# Memorandum to the City of Markham Committee of Adjustment

**Files:** B.002.20, A.028.20, A.029.20  
**Address:** 2 Hughson Drive – Markham, ON  
**Applicant:** Lareina Chan  
**Agent:** Contempo Studio  
**Hearing Date:** Wednesday August 12, 2020

The following comments are provided on behalf of the Central Team.

**APPENDIX "D"**  
**DRAFT REFERENCE PLAN**

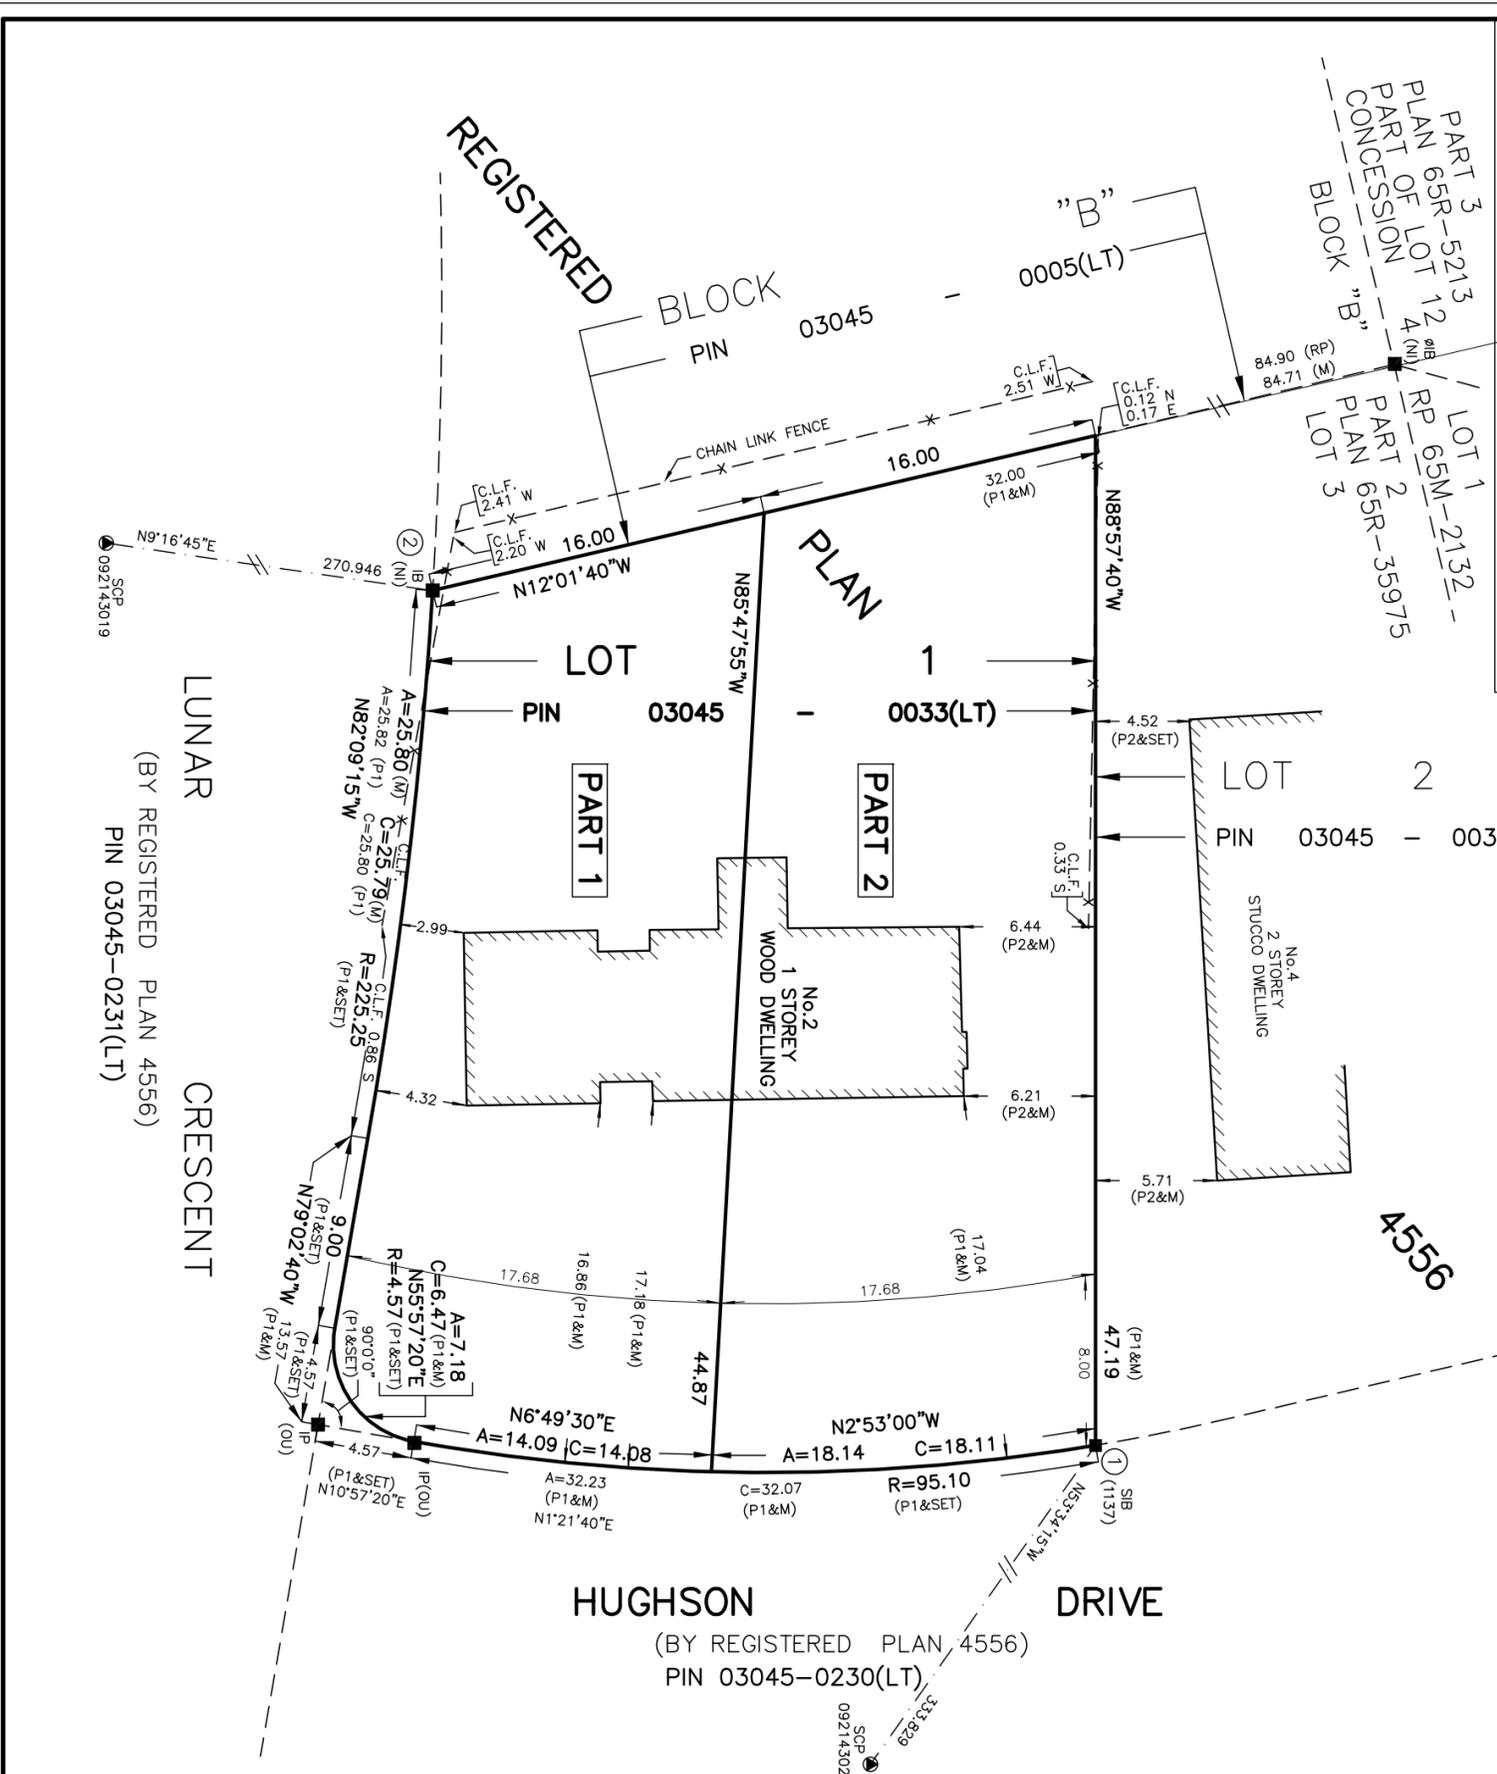
While the lot is generally rectangular, staff are of the opinion that the proposed reduction is due to the existing curvature of the exterior and front lot lines as shown in Appendix "D", which makes it difficult to bisect the property equally. Staff are satisfied the proposed severance line maintains a lot pattern and size that is generally consistent with other lots along the street and within the surrounding area. Accordingly, staff have no objections to the requested variance.

Tree Protection Plan TP1

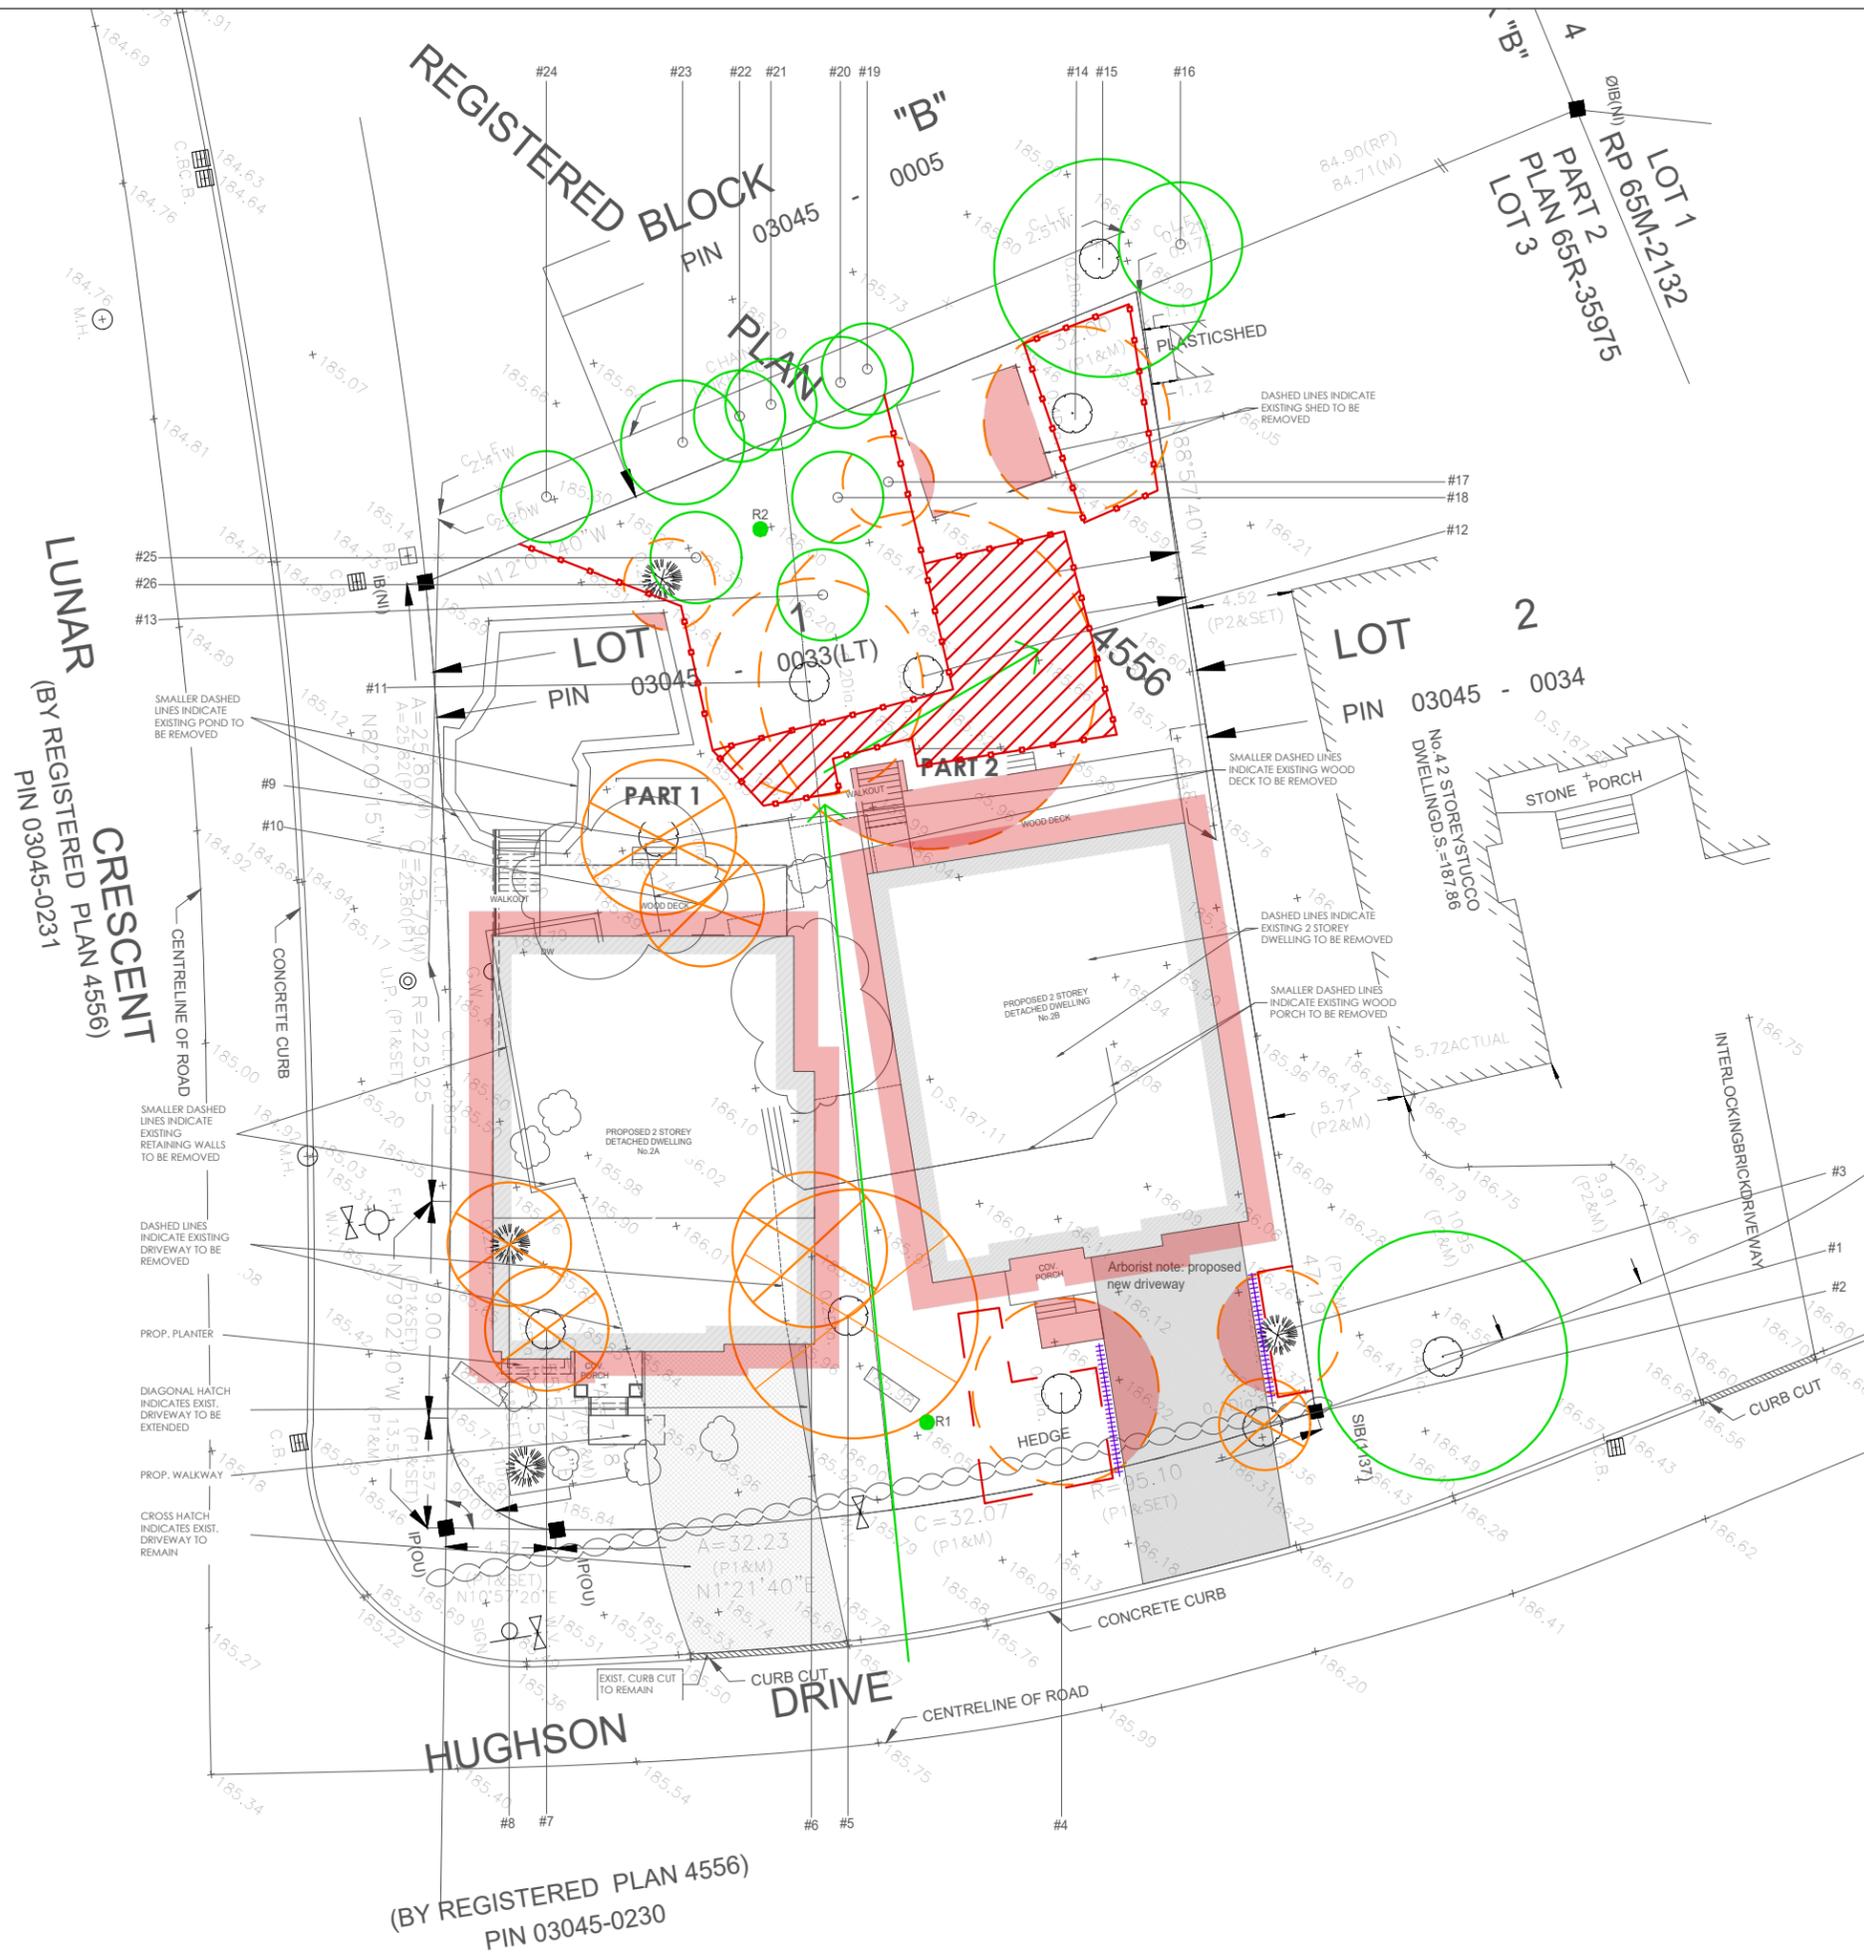
Urban Design staff have reviewed the applications and recommend that the applicant shift the deck stairs on the retained parcel (Part 1) to better protect and minimize potential injury to Tree #9, as shown in the Tree Preservation Plan (Appendix "G"). Tree #9 is located west of the proposed wood deck in the rear yard of Part 1. In response, the applicant submitted a revised site plan, which shifts the stairs north of the tree to protect Tree #9, as recommended.
